February 18, 2020

Regarding: Durgin Square, 1600 Woodbury Ave

Attached please find the complete set of site plans dated 02/18/2020 as well as the Stormwater Summary for the project. In cooperation with Stephen G. Pernaw & Company, Inc., R.J. O'Connell & Associates, Inc. has summarized the following comments received from the TAC via email on January 7th, 2020. We have reviewed the comments listed below in italics with responses following:

DRAWING NUMBER: **C-3**

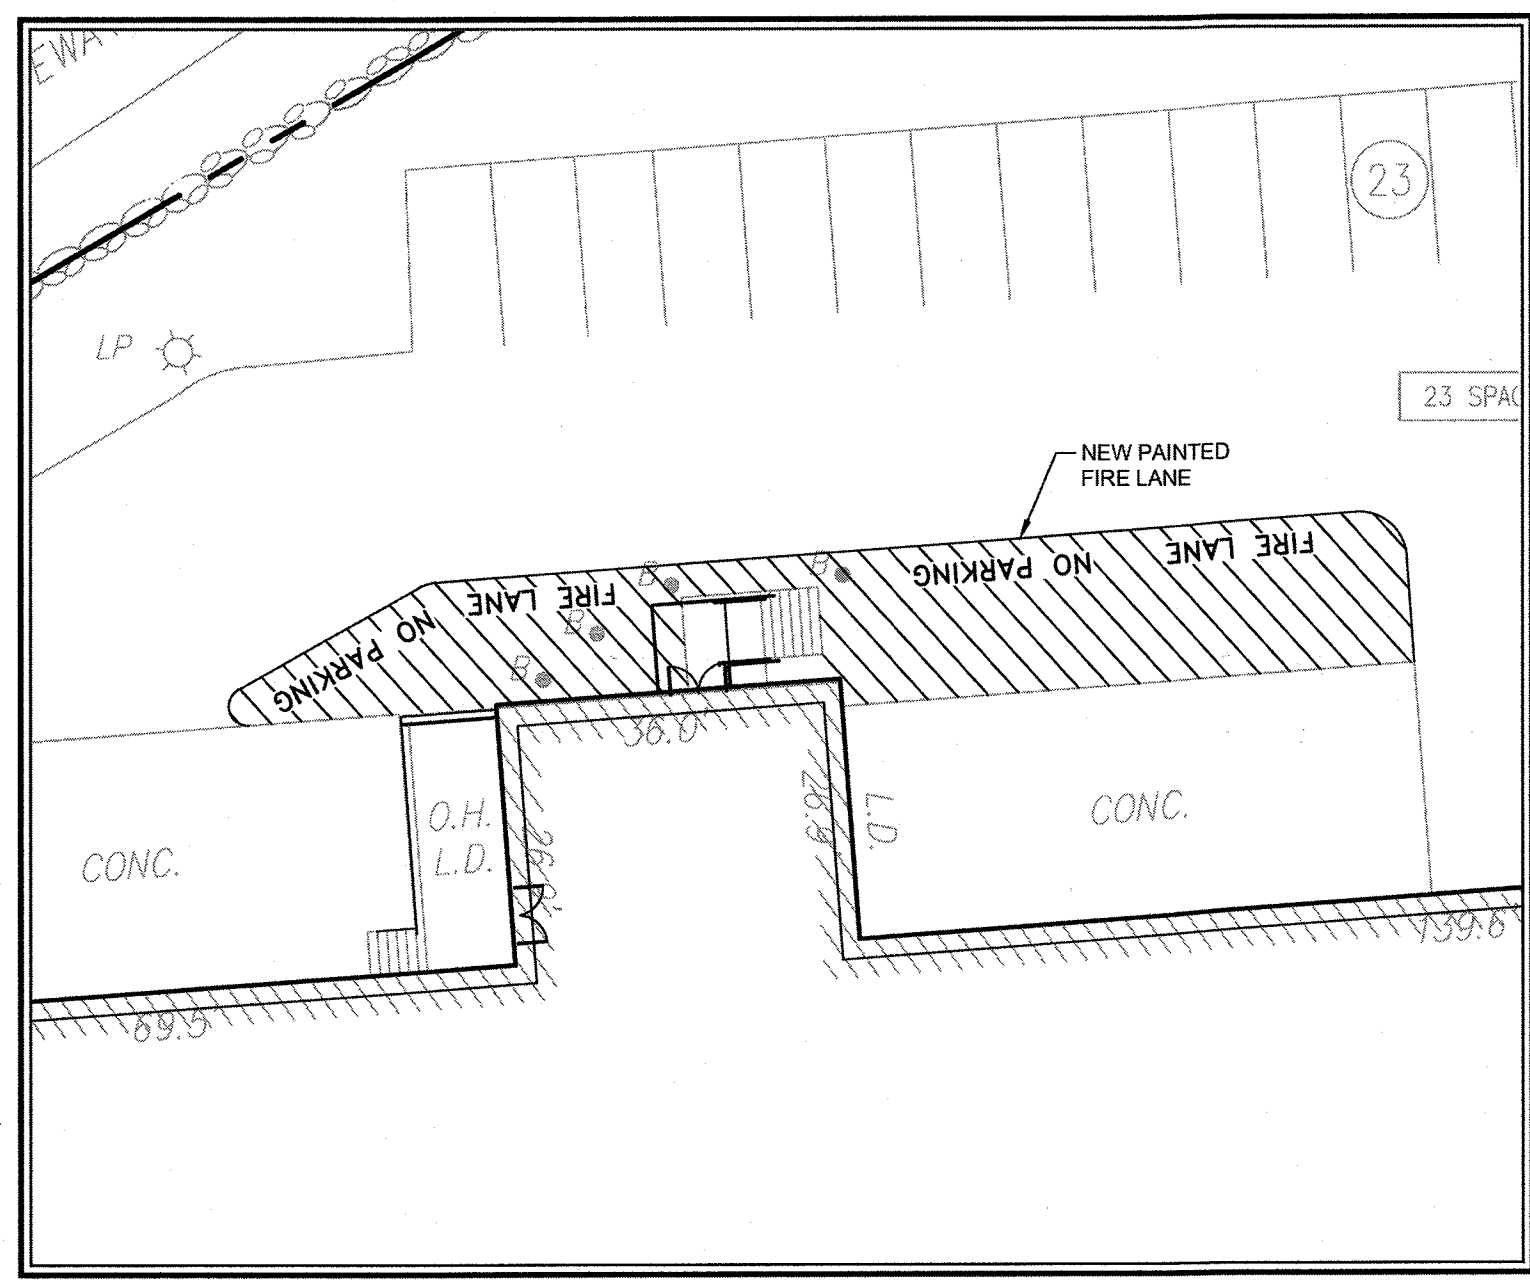
- 1. The National Cooperative Highway Research Program, in their Report 457, provides guidance for when a right turn bay should be provided at an intersection. Based on the speed and volume of traffic on Woodbury Avenue, together with the expected volume of right turns into the proposed driveway, a right turn bay should be provided. A right turn bay can significantly improve operations and safety at the intersection, as it effectively separates those vehicles that are slowing or stopped to turn, from those vehicles in the through traffic lanes. This separation minimizes turn-related collisions such as angle, rear-end, and same-direction-sideswipe, and eliminates unnecessary delay to through vehicles.*

5. *While state driveway standards allow for driving spacing as stated in the memo, the state driveway standards also require 30-foot-wide driveway lanes with a minimum of 20 feet between the entering and exiting lanes of a driveway such as this. There is no separation between the lanes in the proposed driveway design, and the lanes are only 12 feet wide.*

Response: The warrants for requiring a right-turn lane are satisfied based on NCHRP 457 guidelines however, according to the right-of-way line on the Traffic Control Plan, there is not sufficient right-of-way width to accomplish this. Additionally, it would require the relocation of at least 2 utility poles and one mast arm foundation. The design has been revised to provide a longer taper for incoming right turns and the right-out has been eliminated.

Response: The project complies with the 30' throat width guideline, but not the 20' between inbound and outbound lanes. The project proposes a “single drive” per NHDOT Figure III (not Figure IV). The design has been modified to include a single 16' wide incoming right turn lane into the site.

PLANTING PLAN
 DRAWING NUMBER: **L-1**
 PROJECT NUMBER: 16030
 Copyright © 2019 by R.J. O'Connell & Associates, Inc.

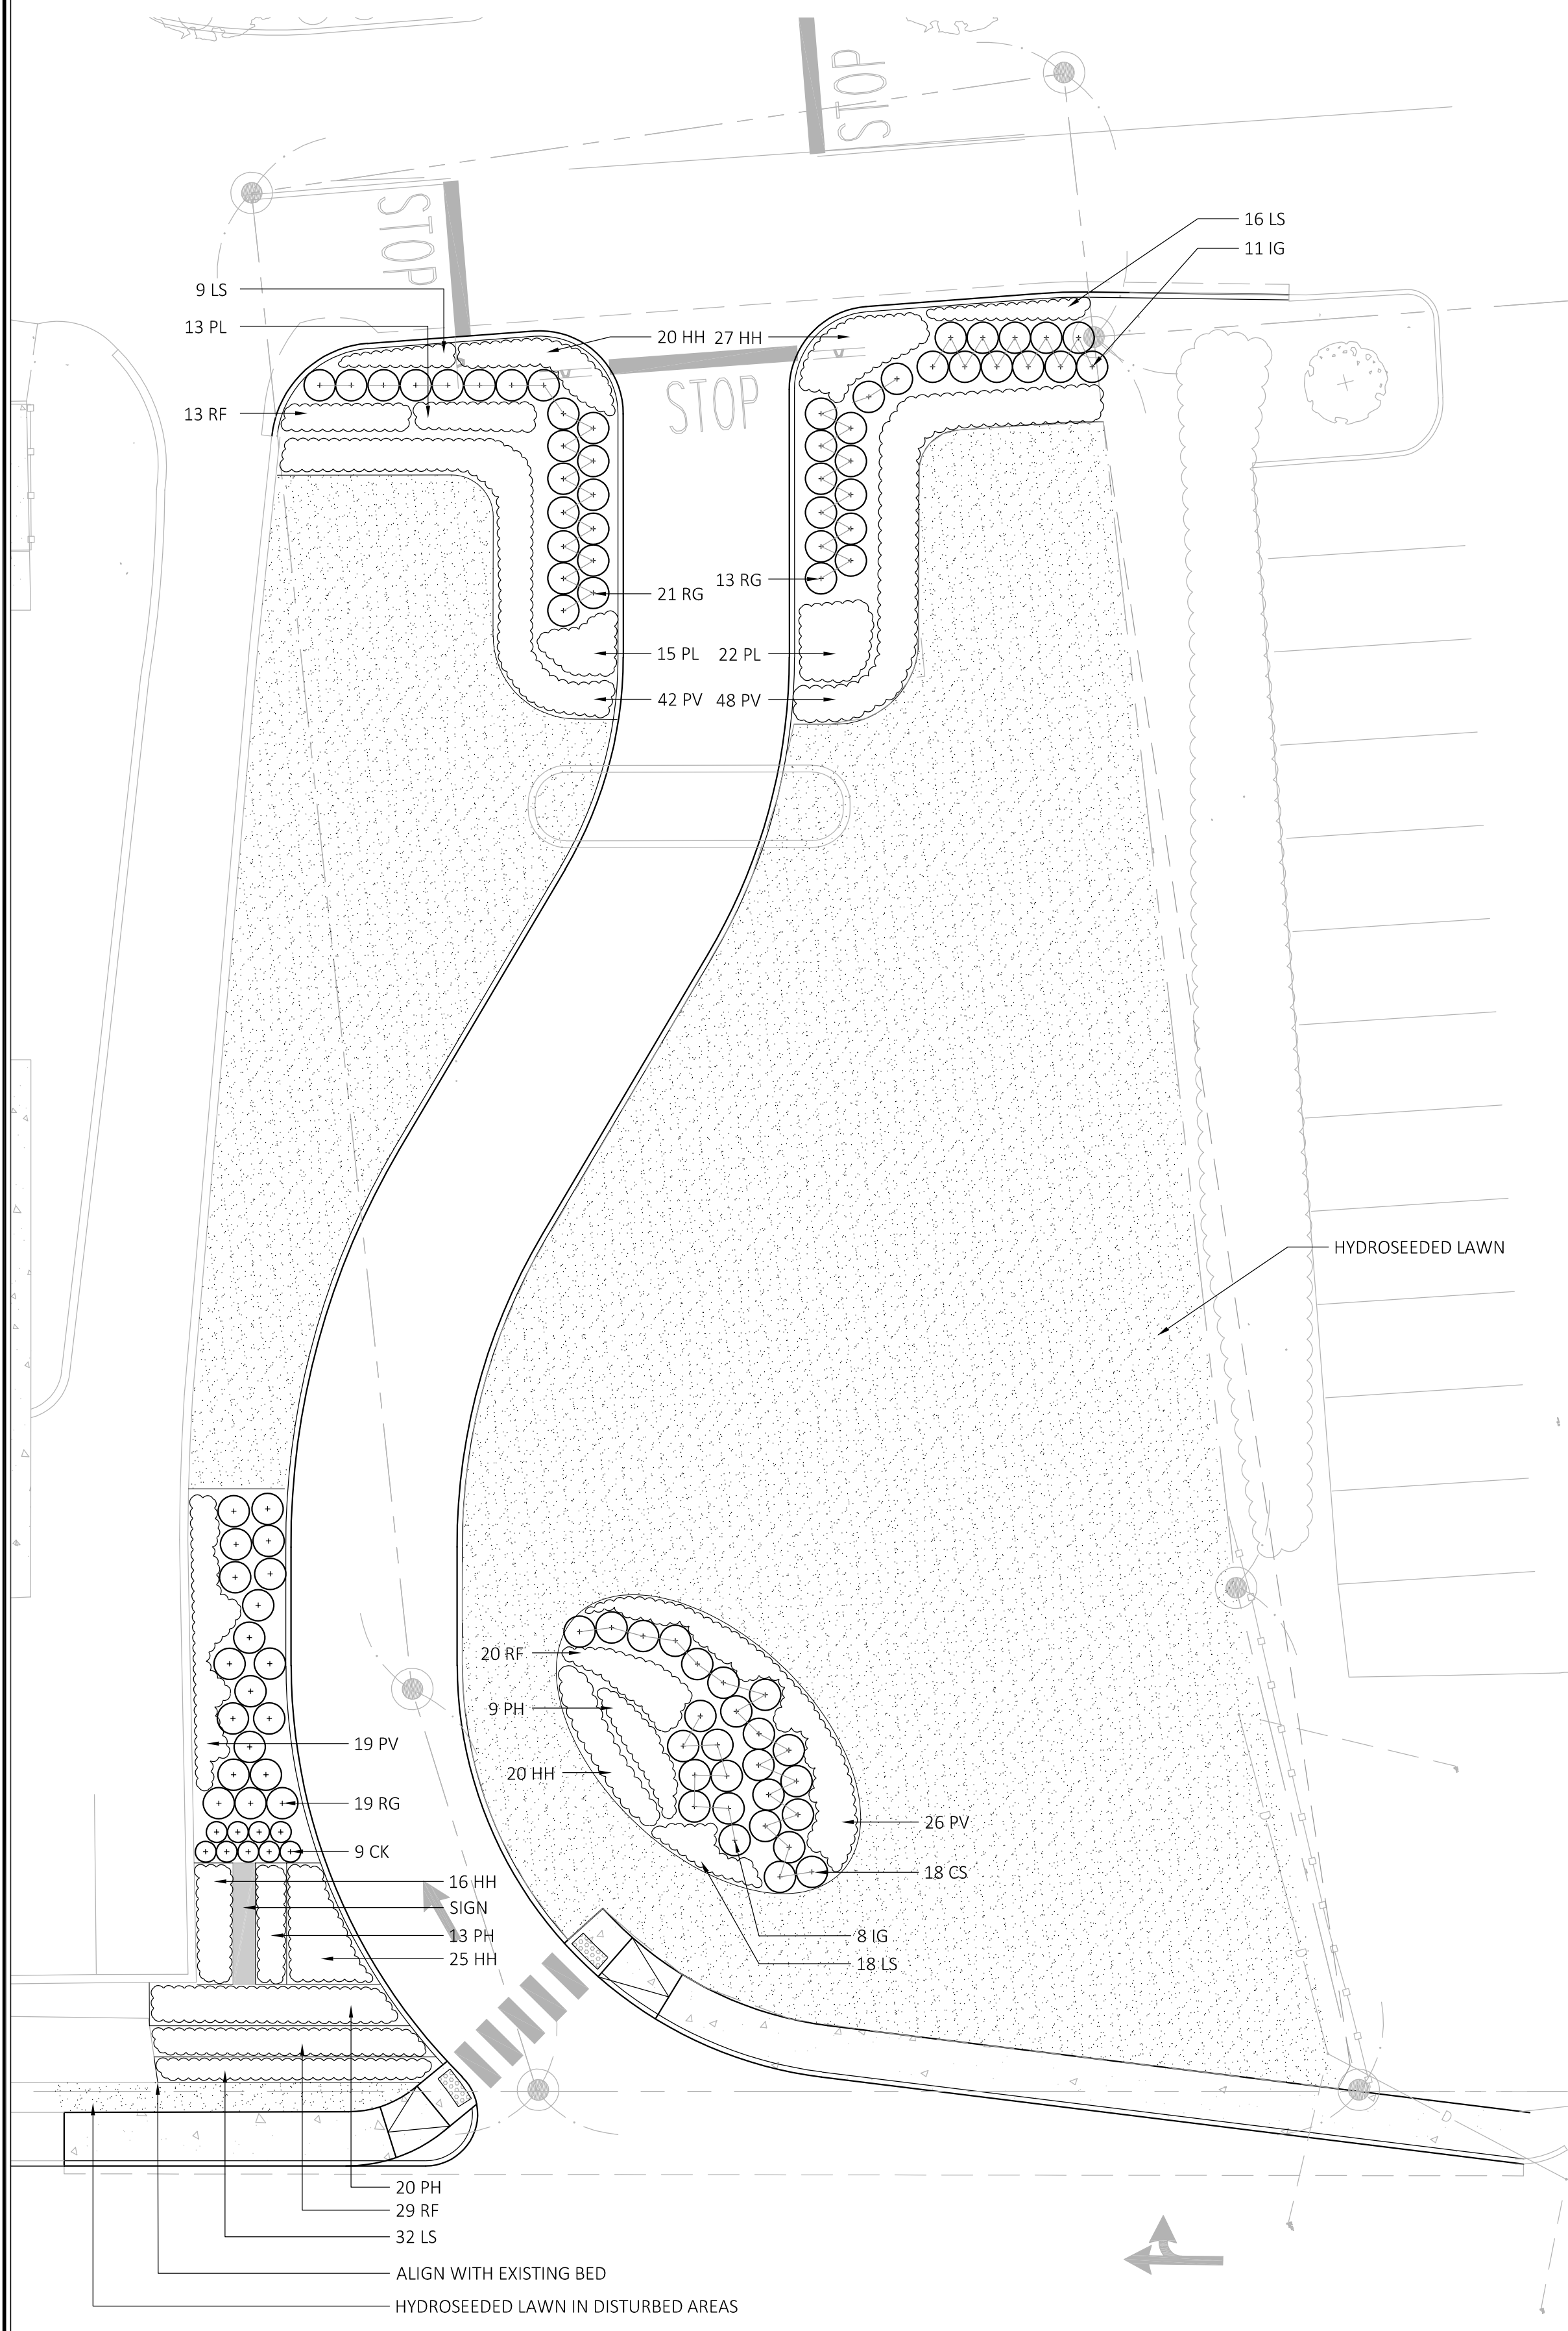
8. *A line of shade trees should be considered for the wide landscape areas adjacent the proposed driveway. In order to maintain views into the site the trees could be planted toward the rear of the landscape area.*

Response: Shade trees would inhibit the view corridor to the proposed supermarket. The Planting Plan provides areas of shrubs and shorter plantings.
